DEVELOPMENT REVIEW COMMITTEE (DRC) COMMENT REPORT

PROJECT NAME: U-Haul Facility 788054

CASE NUMBER: UDP-SR21002

REQUEST: Site Plan Level IV Review: Rezoning from Residential Multifamily Mid Rise/ Medium High Density (RMM-25) to Community Business District (CB) with .10 Acres of Commercial Flex Allocation for a 132,984 Square-Foot Self-Storage Facility

Exhibit 2: 4551 W Sunrise Blvd, Plantation, FL 33313

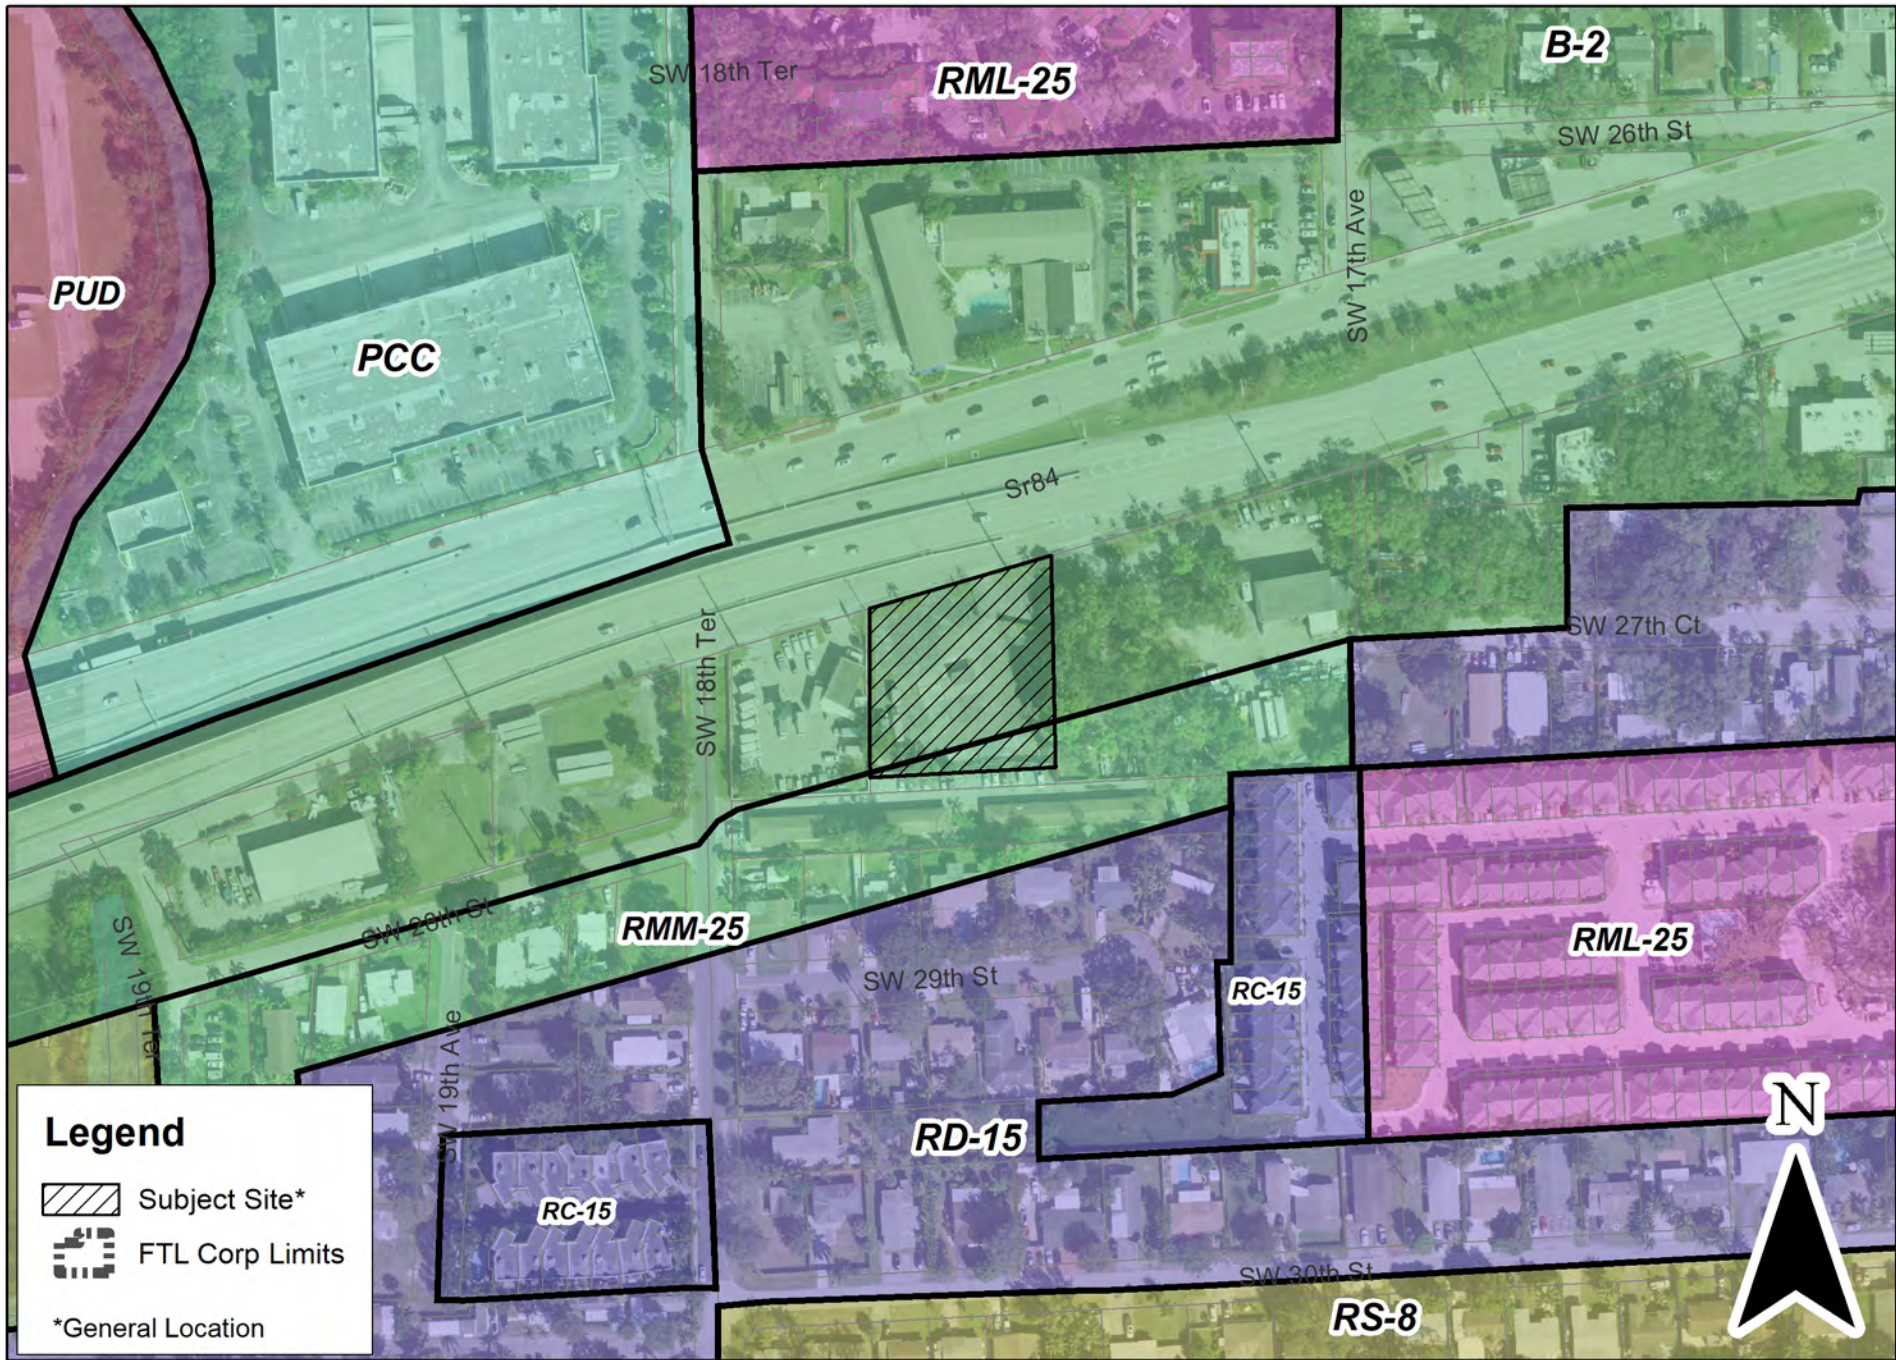
2. Per Section 47-25.3.A.3.e,- *Neighborhood compatibility requirements*, "Development will be compatible with, and preserve the character and integrity of adjacent neighborhoods, the development shall include improvements or modifications...to mitigate adverse impacts such the alteration of building mass, and the addition of landscaping, walls, or both, to ameliorate such impacts". To meet the requirements of this section, consider integrating additional architectural elements into the building design, such as use of high quality building material, the inclusion of rectangular features of the proposed building. Exhibit 1 and Exhibit 2 are attached as design examples.

- (a) Exhibit 1 and Exhibit 2 provide a strong street presence along a high traffic corridor similar to State Road 84. Architectural elements include fenestration, banding, changes in roofline/parapet wall elevations, projection and recession, high quality materials, cornice, awnings, and Bahama shutters.

- (b) Exhibit 2 shows transition and proximity to residential uses. Focus has been placed on rear architectural features and design aesthetics.
 - b. Show setback dimensions from the property lines on the elevation pages.
